APPLICABILITY: 2015MY Forester

NUMBER: 07-92-15

SUBJECT: Condensation (Fogging) in Rear Combination Lamps

DATE: 07/08/15

Rear view of the new combination lamp showing the 6 additional breathing holes.

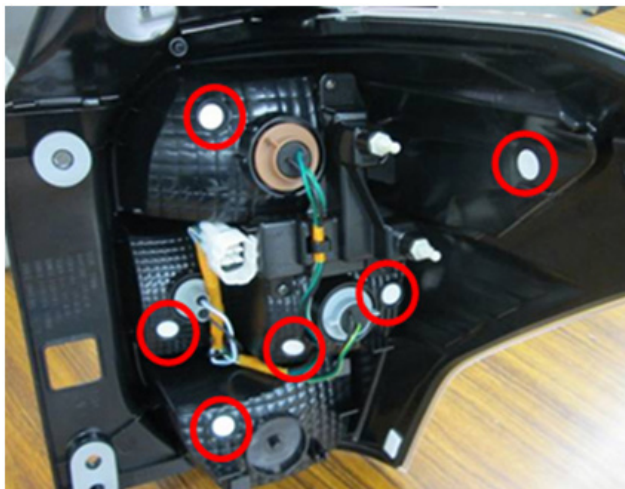
This **Service Information** bulletin announces a design change to the rear combination lamps to address customer concerns of fogging or condensation accumulating on the inside surface of the lens. Six additional breathing holes have been added to the body of the lamp assembly. The additional holes are intended to provide additional ventilation and prevent fogging which may result when severe ambient temperature changes occur.

The new combination lamps were incorporated into production starting with VIN F*530822.
